Please substitute these replacement drawings for the drawings now on file in the above-identified patent application.

Amendment After Allowance under 37 CFR 1.312

FIG. 1

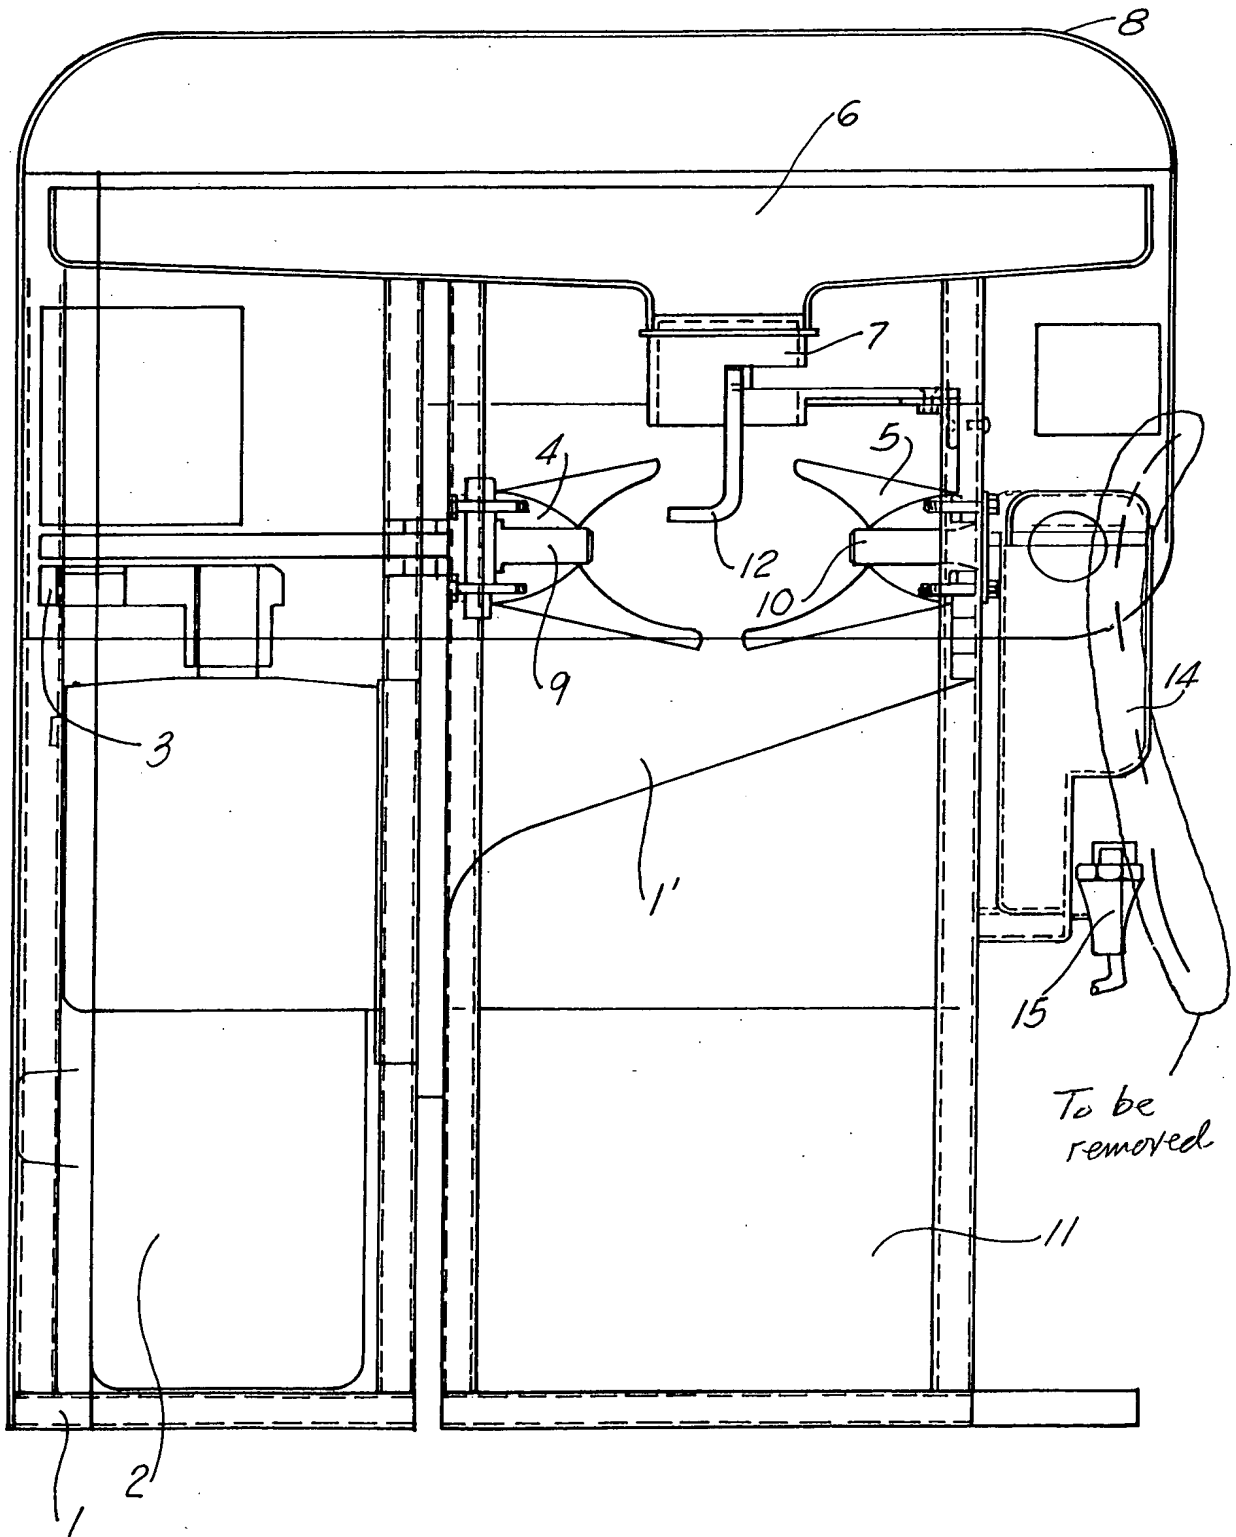
Specifically regarding FIG. 1, a curved pattern of dashed lines, not mentioned in the application and apparently inadvertently provided in the original FIG. 1, has been removed. An annotated sheet with this is provided in which the curved pattern of dashed lines is encircled.

FIG. 3

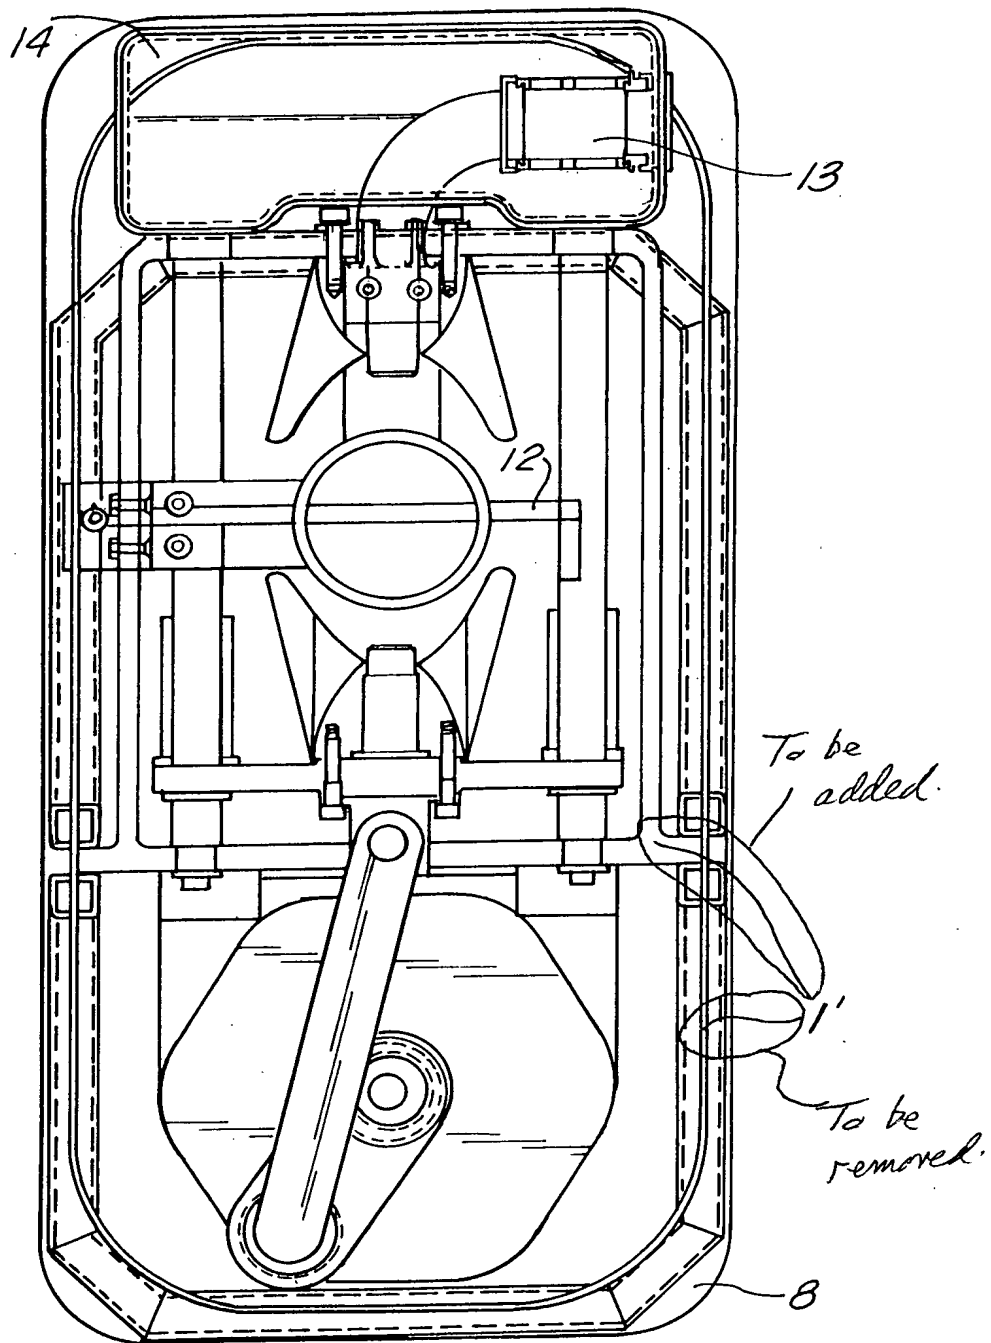
Specifically regarding FIG. 3, the lead line for 1' is corrected, as it was inadvertently leading to the wrong element. An annotated sheet with this is provided in which the old and the new lead lines are encircled. Support for this correction is found in FIGs. 1 and 2, and also in the specification, page 11, lines 3-11, which identify "... a tubular chassis 1, affixed to an extraction box 1' ...".
